BY: Rob Young
DATE: 03/24/2014
CONFORMANCE
and Checked for
ON: March 17, 2014
RECEIVED
Vermont Agency of Transportation

THE STAMPED DOCUMENTS ARE HEREBY:

Project: BRIDGE REPLACEMENT #1
CAVENDISH, VT

Drawing: DECK REINF

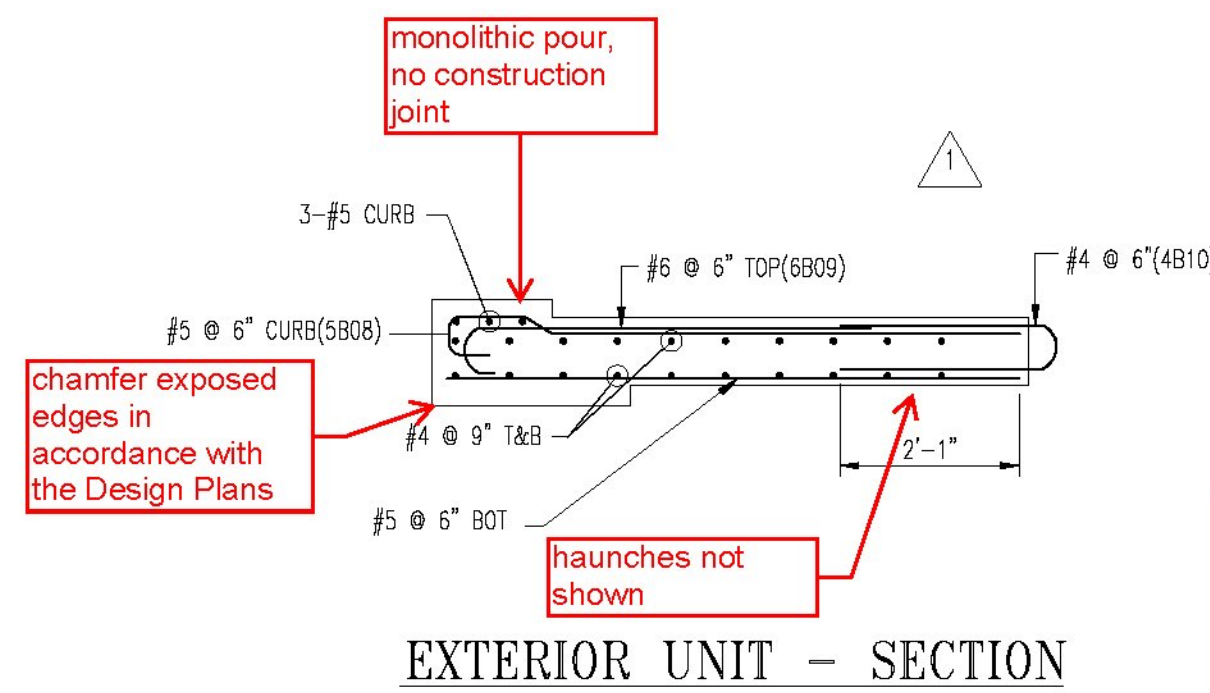
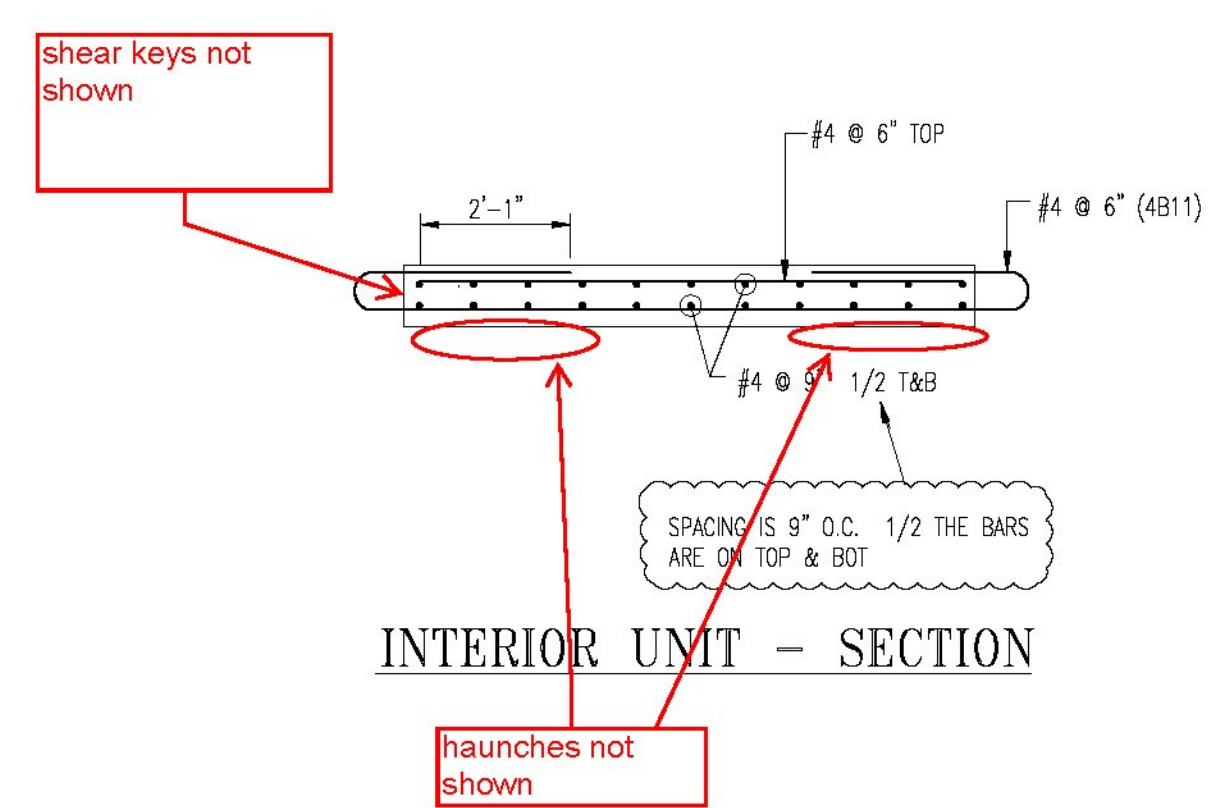
concrete cover (reinforcement clear cover) needs to be in accordance with the design plans
